Applicant: Matti Hietaniemi
PCT App. No.: PCT/FI2004/000058

Amendments to the Drawings:

FIG. 1A

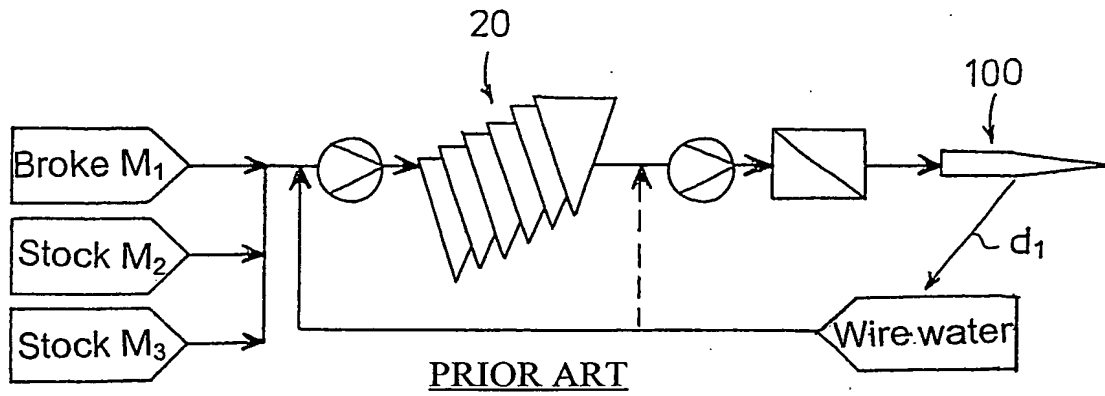
In FIG. 1A a legend denoting prior art has been added.

FIG. 1B

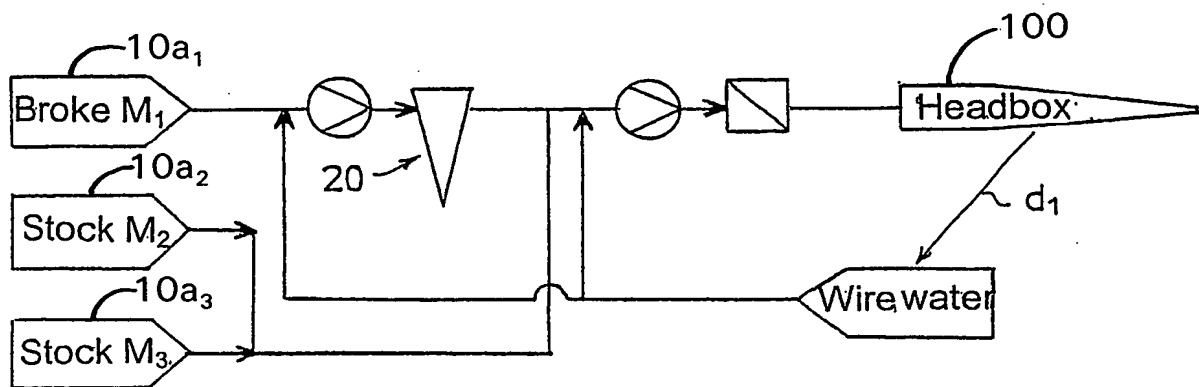
In FIG. 1B, the call-out numbers 10a₁, 10a₂, 10a₃, and 100 have been supplied as described in the specification.

FIG. 2A

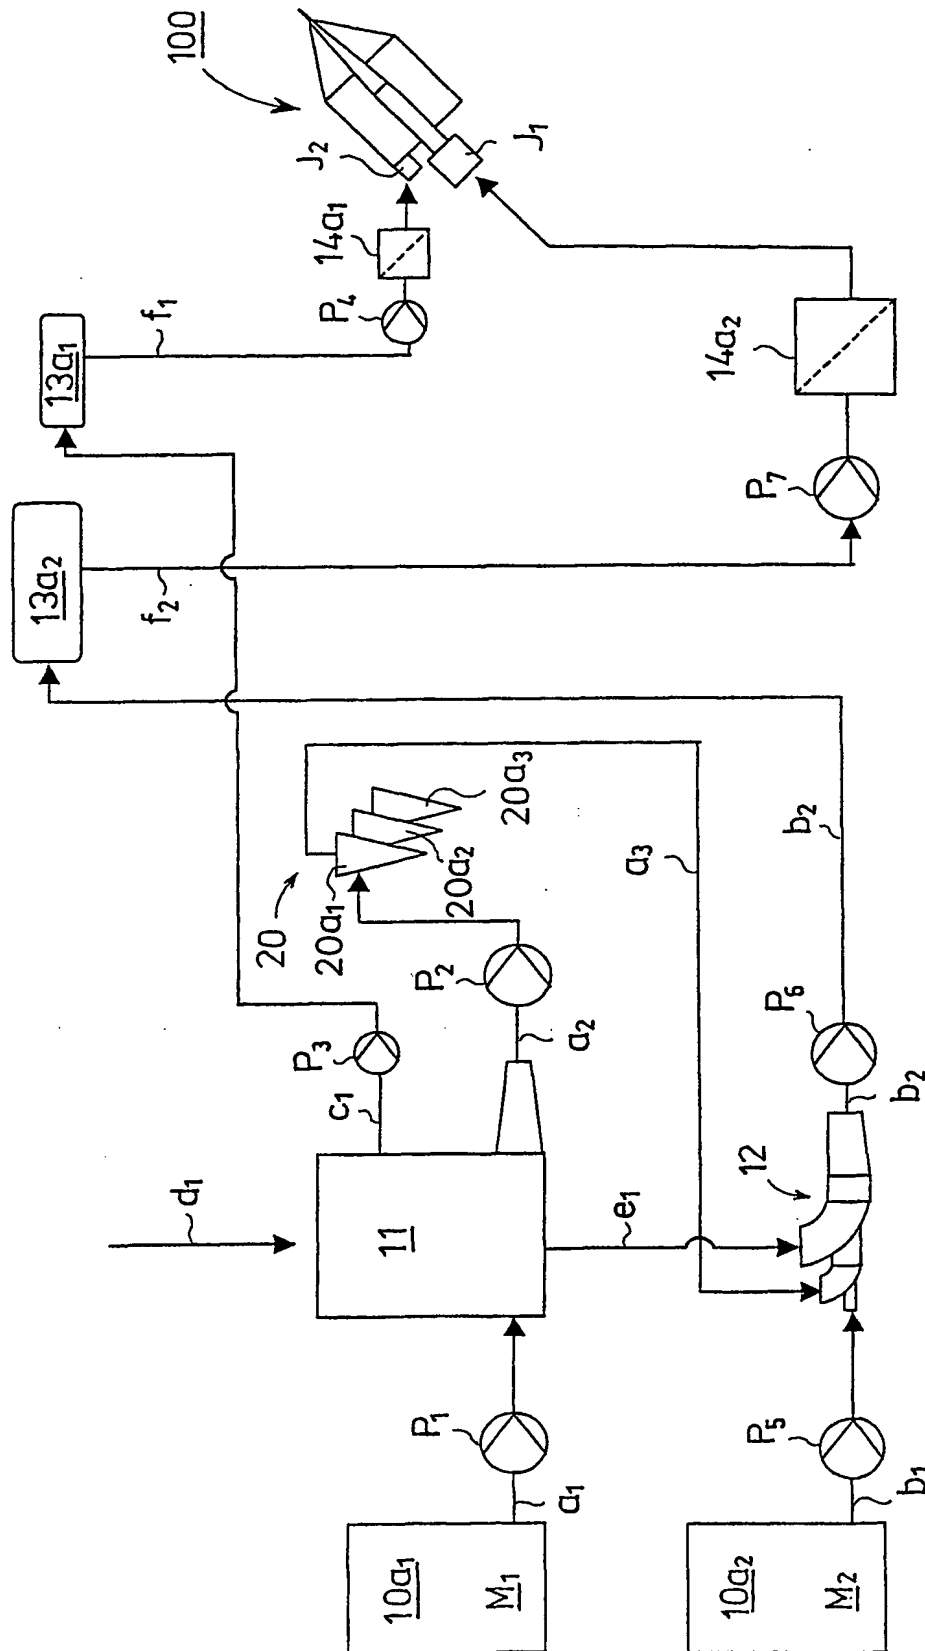
In FIG. 2A, the call-out numbers 21a₁, 21a₂, 21a₃ have been corrected to 20a₁, 20a₂, 20a₃, to conform to the specification.
